NORTHERN STATES POWER COMPANY

PRAIRIE ISLAND NUCLEAR GENERATING PLANT
Docket No. 50-282 License No. DPR-42
50-306 DPR-60

Control of Heavy Loads Near Spent Fuel

AUXILIARY BUILDING

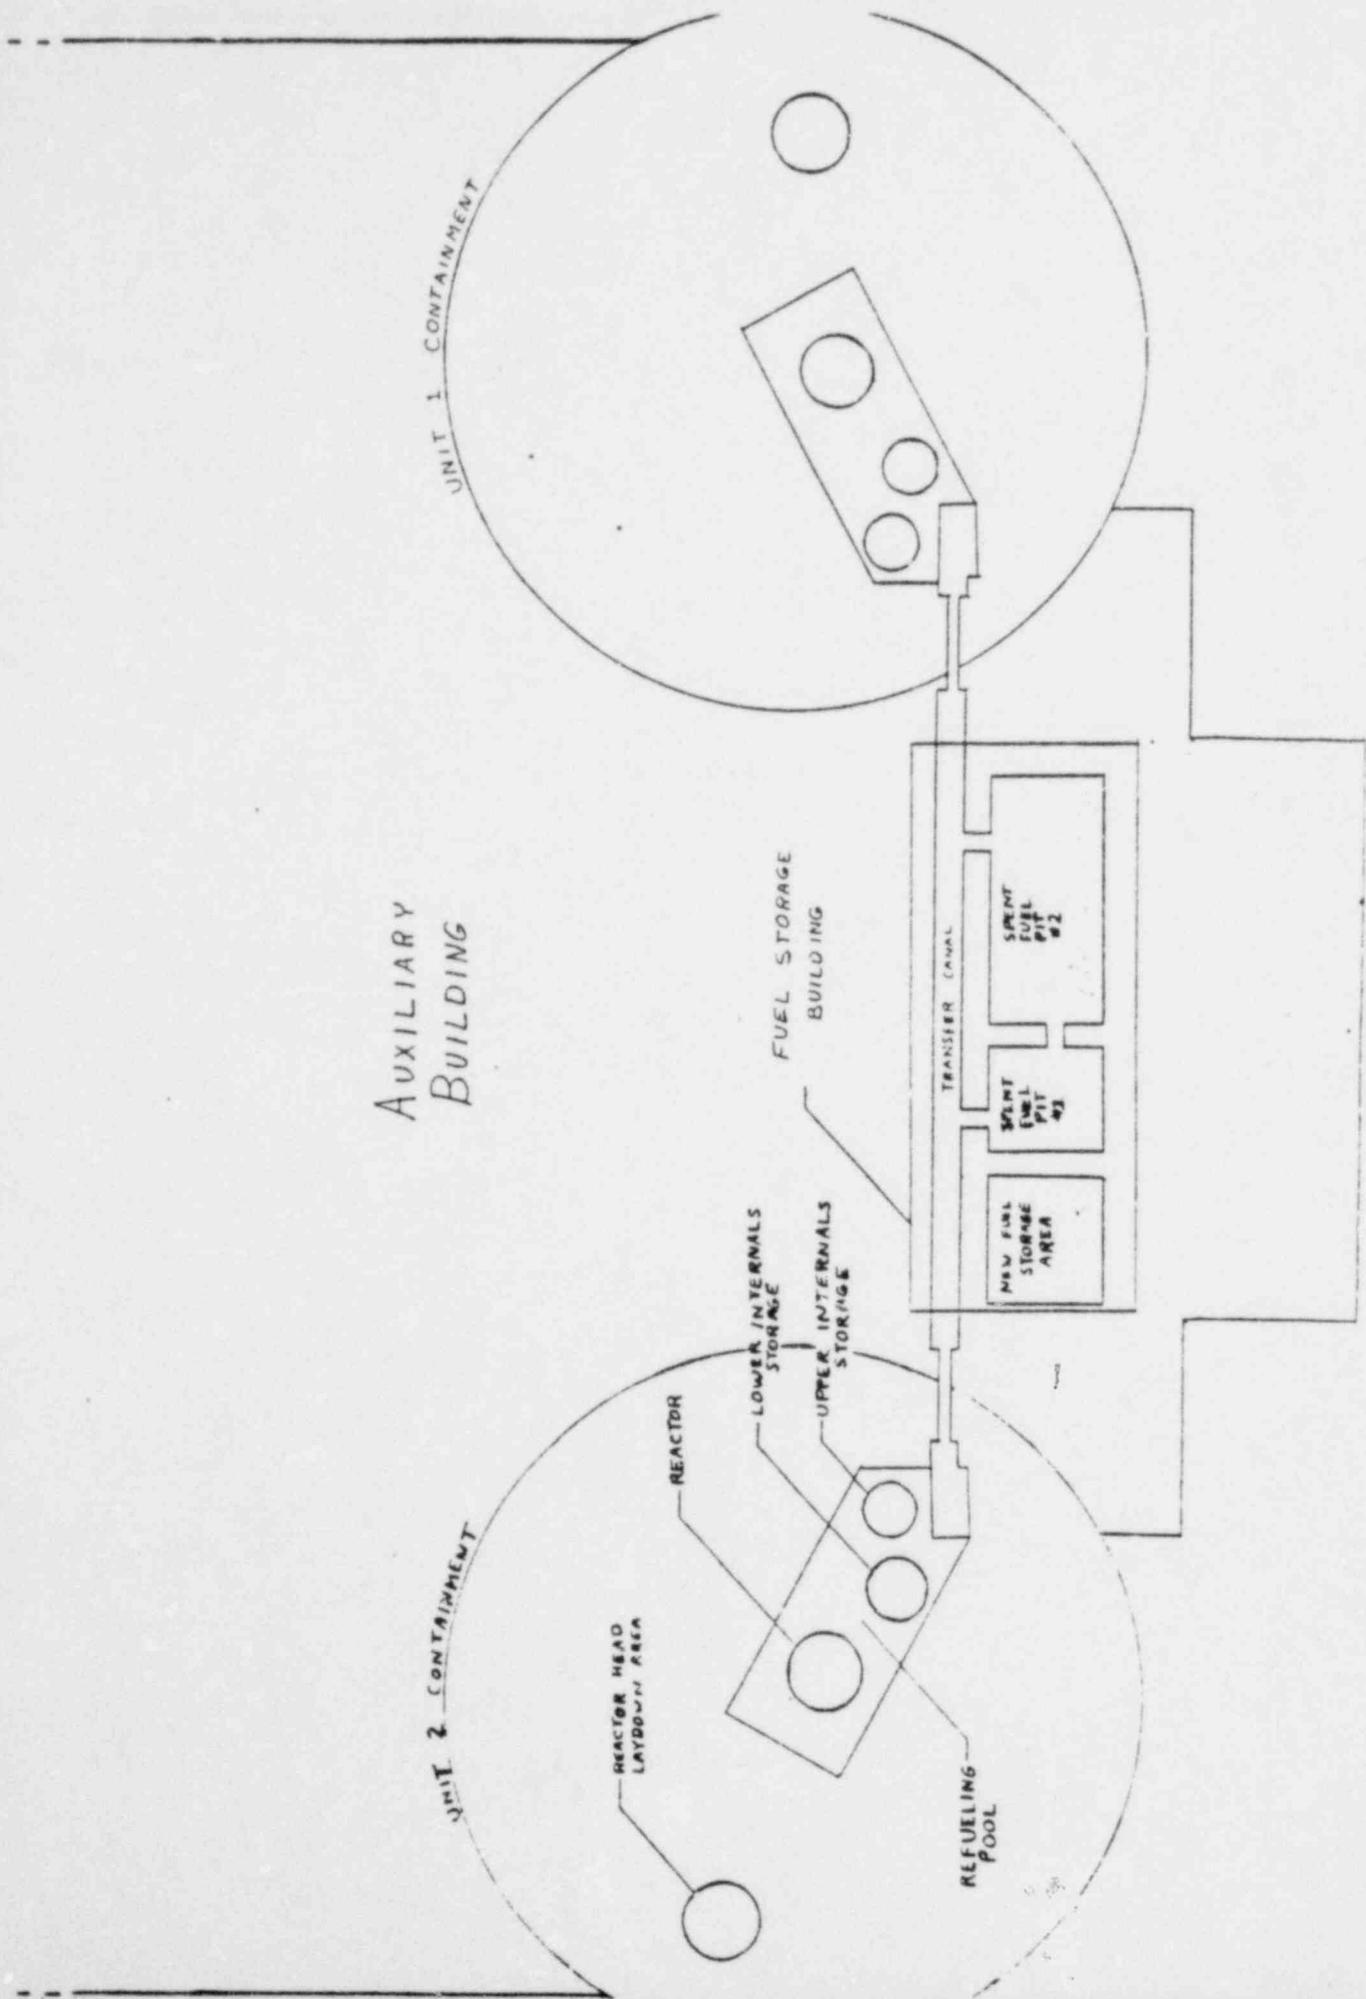
Provide a diagram which illustrates the physical relation between the reactor core, the fuel transfer canal, the spent fuel storage pool and the set down, receiving or storage areas for any heavy loads moved on the refueling floor.

These diagrams are attached. Additional diagrams can be found in the Prairie Island FSAR
